# PERMIT

## SEWAGE DISPOSAL SYSTEM

**HOWARD COUNTY HEALTH DEPARTMENT**

SUBDIVISION Jack Ryan Property LOT 1 ROAD 410 Morgan Station Road

Lot 1 - JEKEL  
 410' MORGAN STATION RD (THE NORTH LOT)

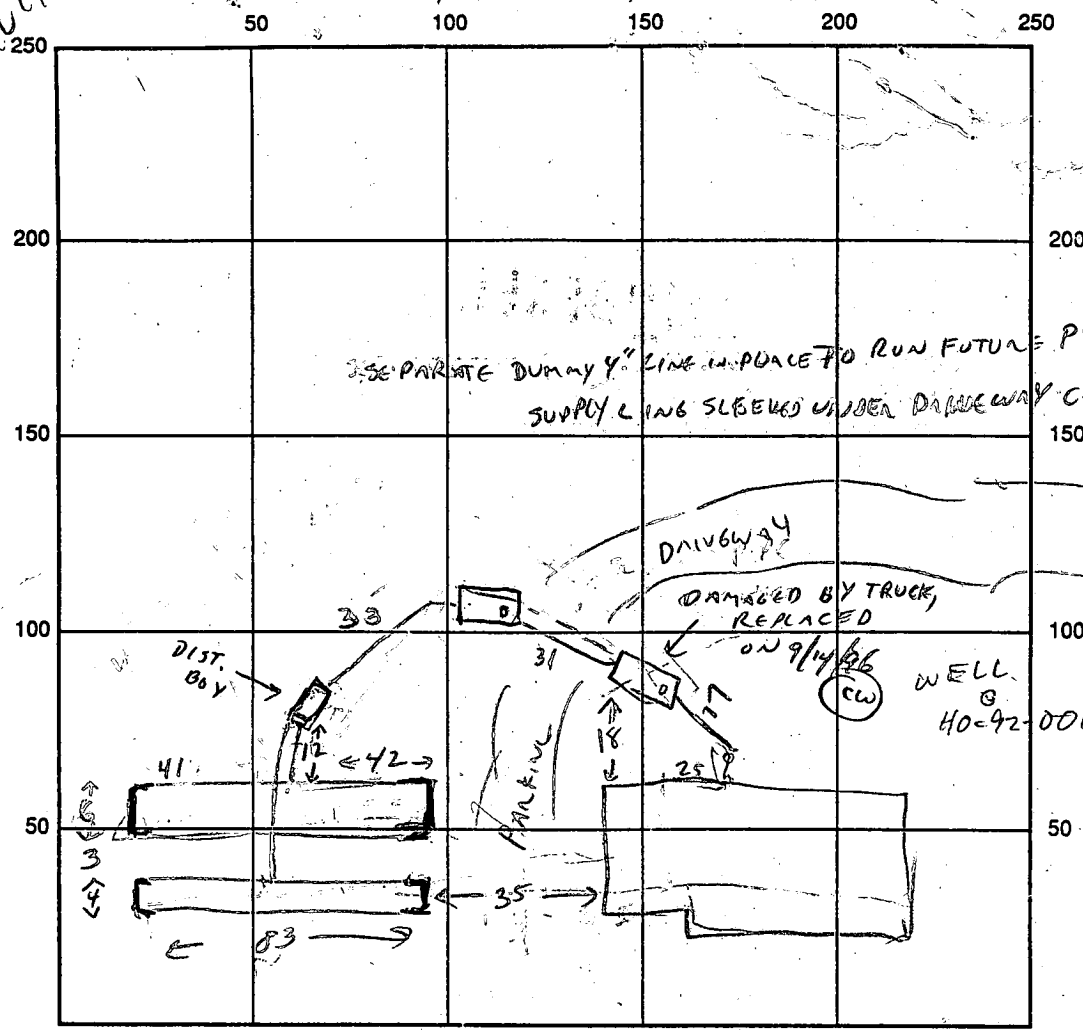
TANK DAMAGED BY DUMP TRUCK

REMARKS: 5/23/96 - SITE INSP W/ CONTRACTOR; HOUSE LOCATION LOOKS LOW, MAY NEED PUMPED SYSTEM  
SITE IS HEAVILY TREED; INFILTRATION DESIGN UNDER CONSIDERATION FOR EASE OF INSTALLATION IN FUTURE  
6/21/96 - SEPTIC TANK AND HOUSE SEWER LINE COMPLETE. CONTRACTOR TO REQUEST SEPTIC AREA BE STAKED  
8/28/96 GRAVITY SERVICE TRENCHES INSTALLED AT LOW END OF SEPTIC  
EMBAYMENT, TRENCH CONFIGURATION MODIFIED DUE TO DIFFICULT SITE CONDITIONS - TREES, SLOPE, ROCK,  
9/12/96 - SEPTIC TANK PARTIALLY COLLAPSED - TRUCK DAMAGED. 9/14/96 COMPLETE TANK REPAIR

Approved Septic System Plan  
 Howard County Health Department

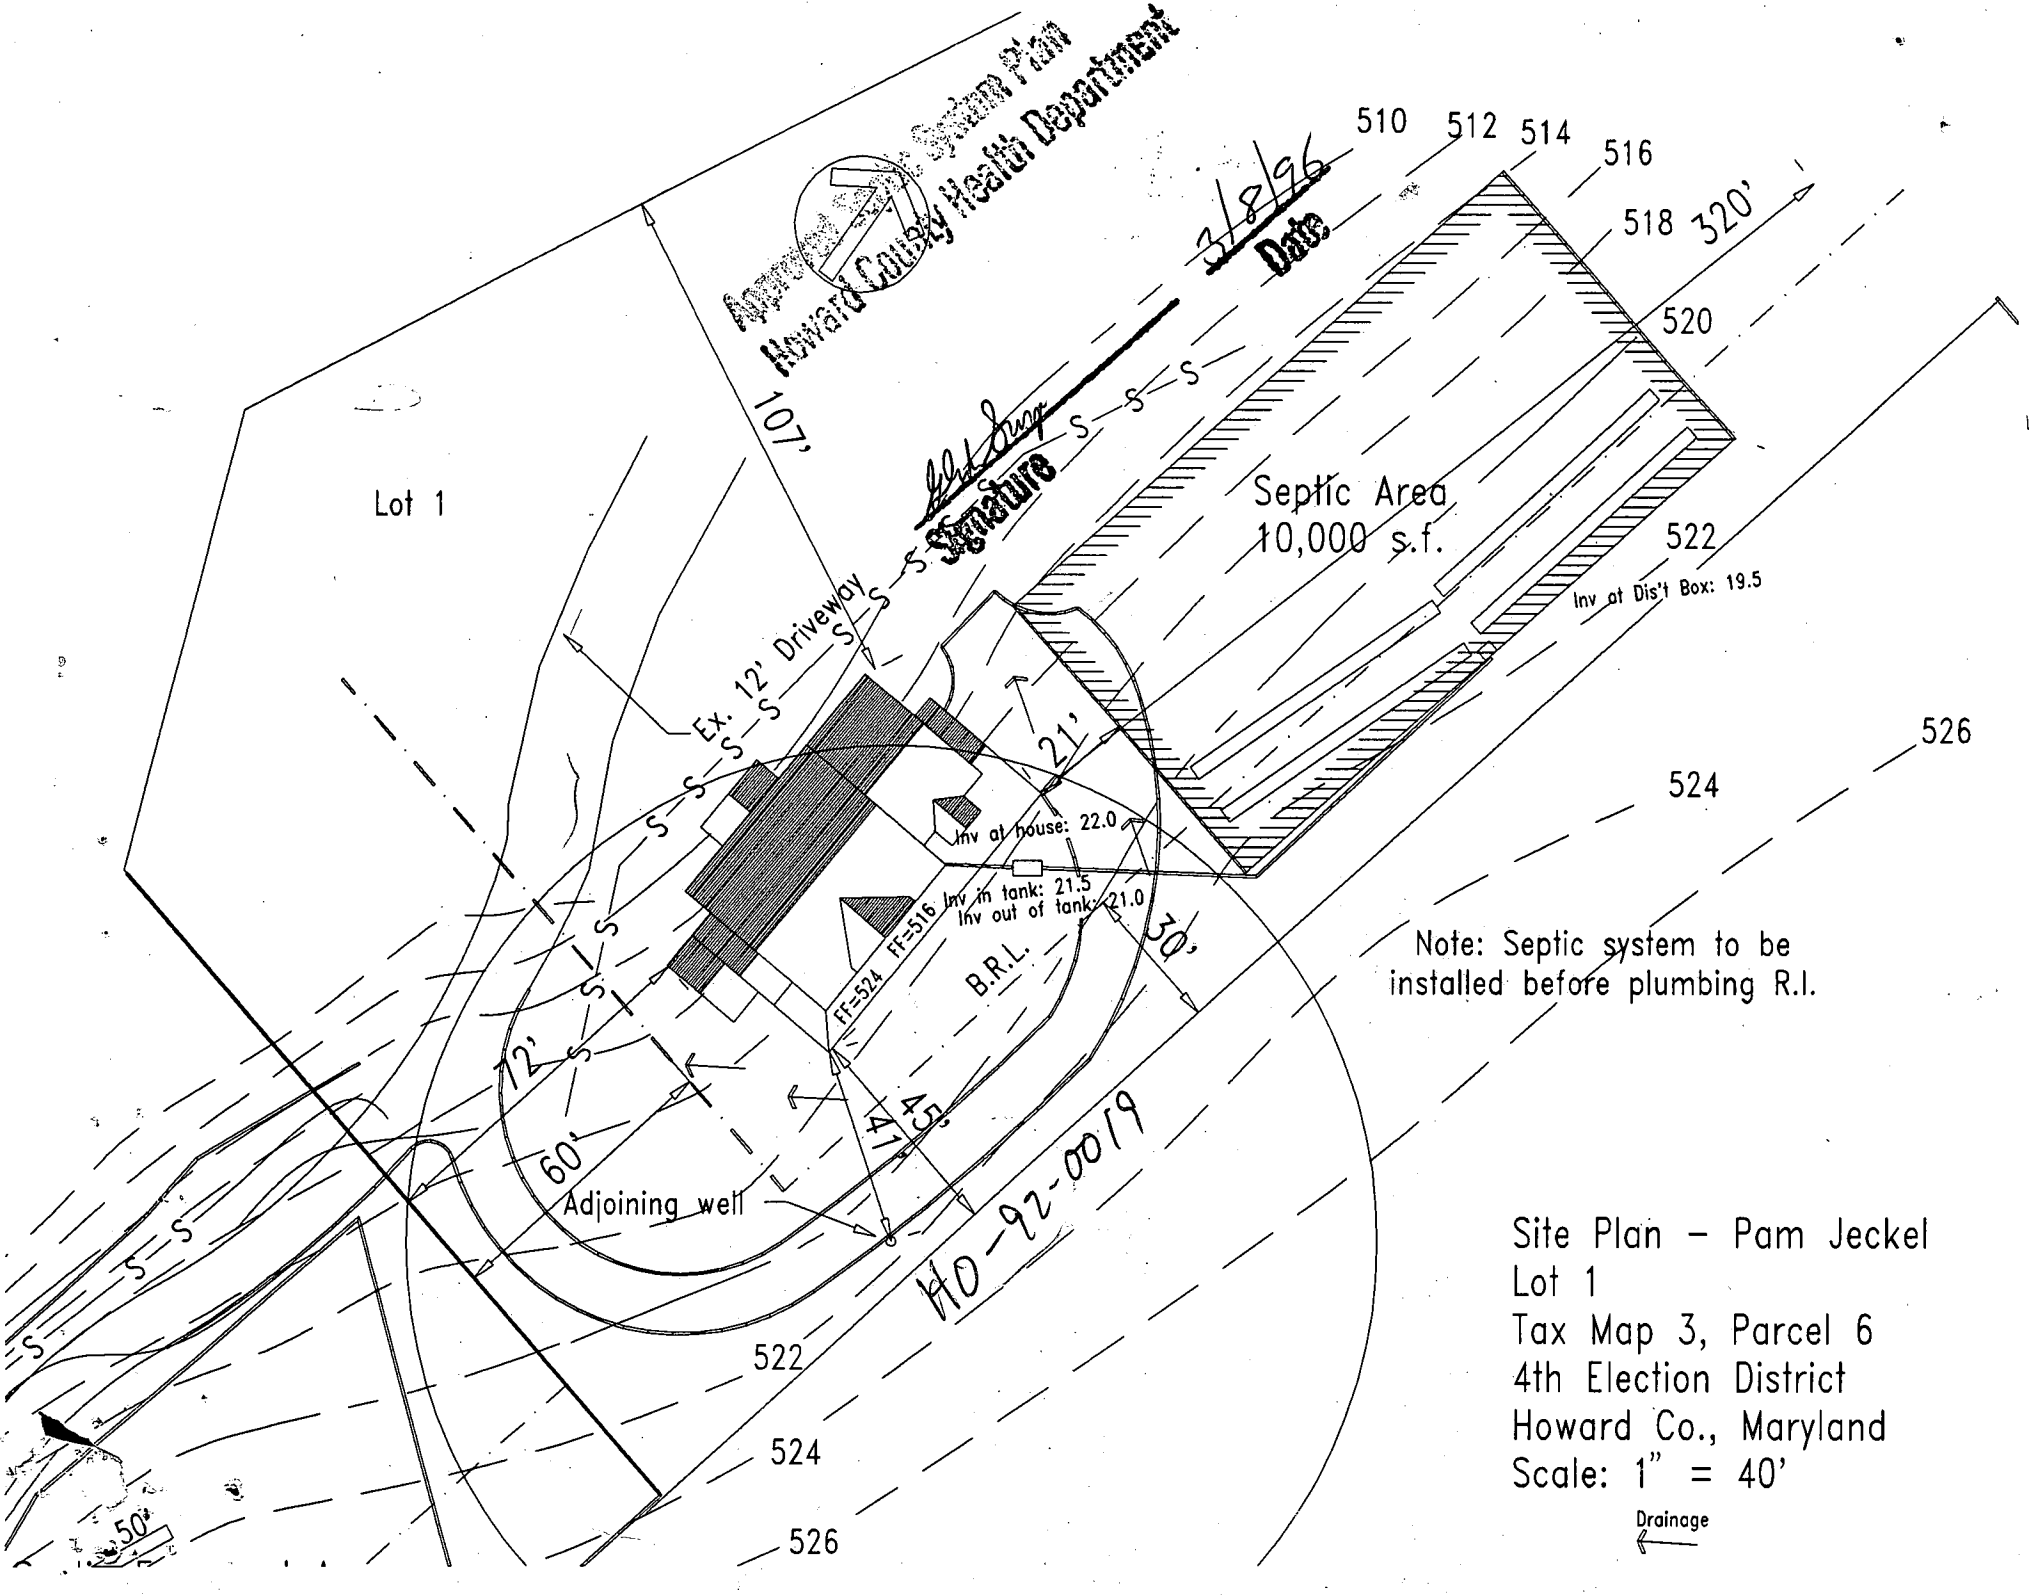
Would like to do additon,  
says ~~that~~ septic locations  
on this drawing not correct  
would like to do site insp.  
prior to bp process to  
avoid hassks. C. Williams  
drawing pretty good may  
be able to permit addition  
w/o site insp. (GAC)

Proposed Sewage Easement  
Revision For Lot 1  
OCTOBER 23, 1995

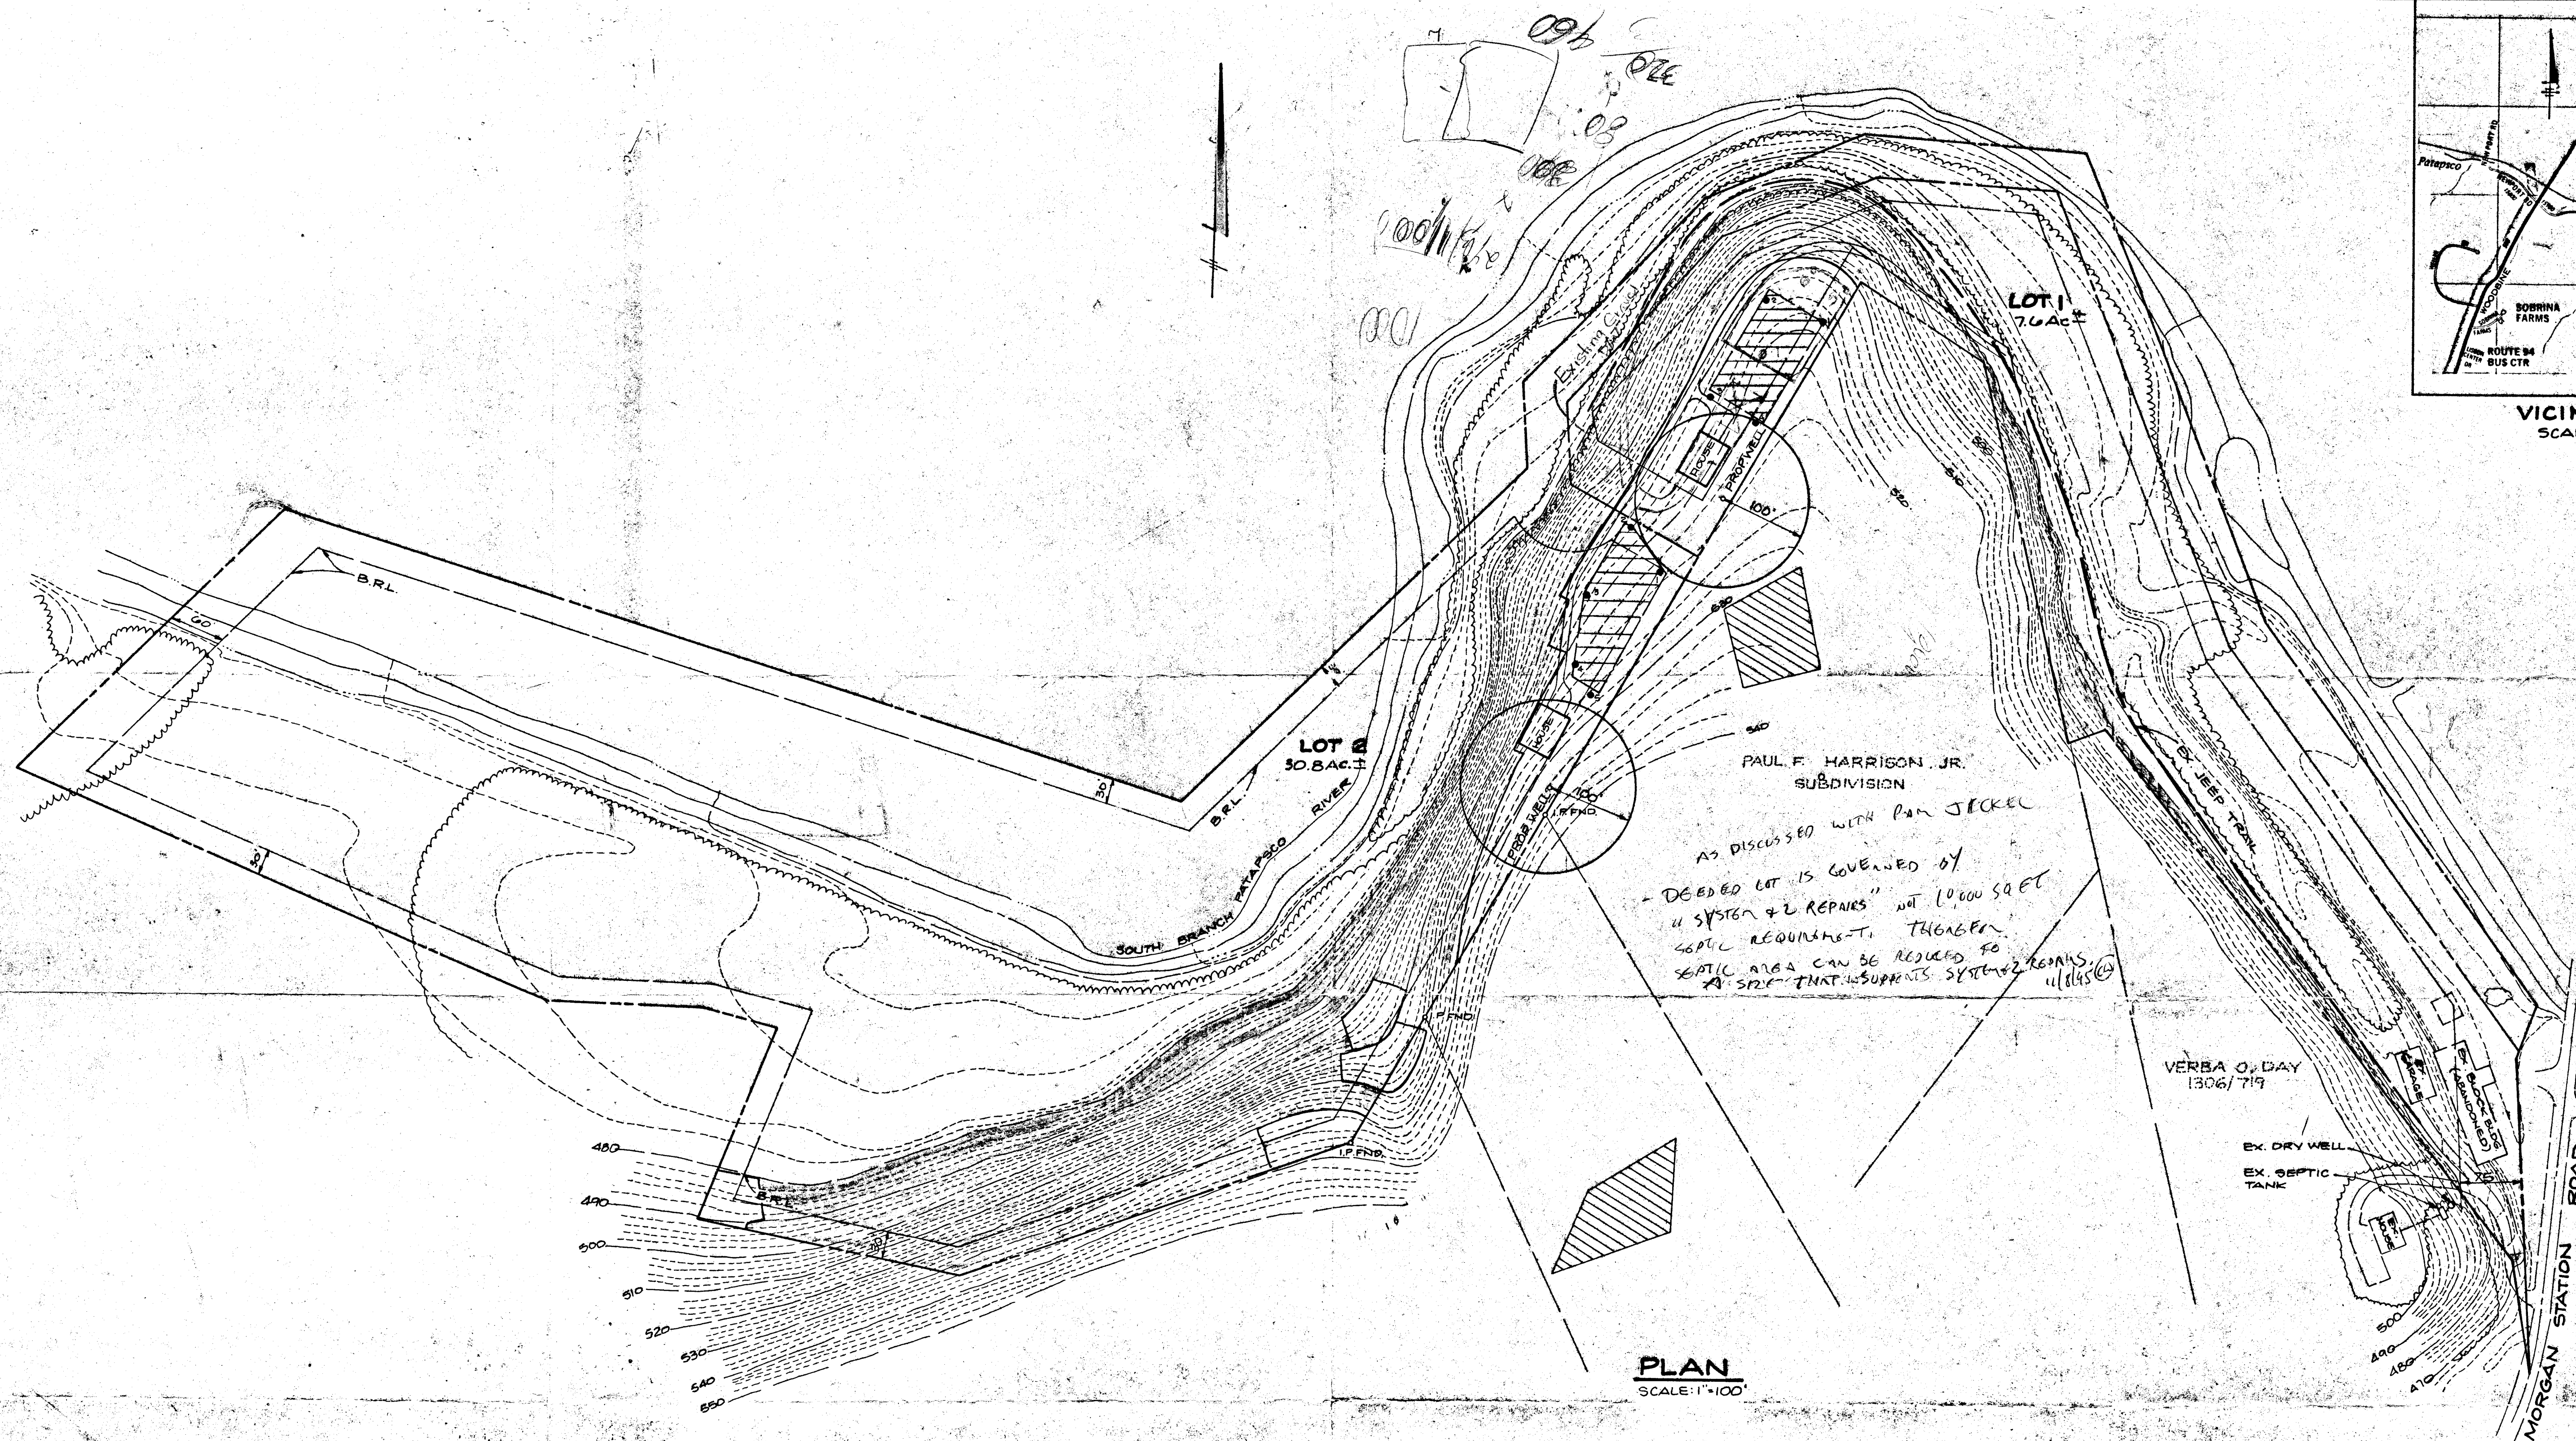
AS DISCUSSED WITH PAUL JECKEL  
- DEEDED LOT IS COVERED BY  
"SYSTEM #2 REPAIRS" NOT 10,000 SQ FT  
SEPTIC REQUIREMENT. THEREFORE  
SEPTIC AREA CAN BE REDUCED TO  
A SIZE THAT SUPPORTS SYSTEM #2 REPAIRS
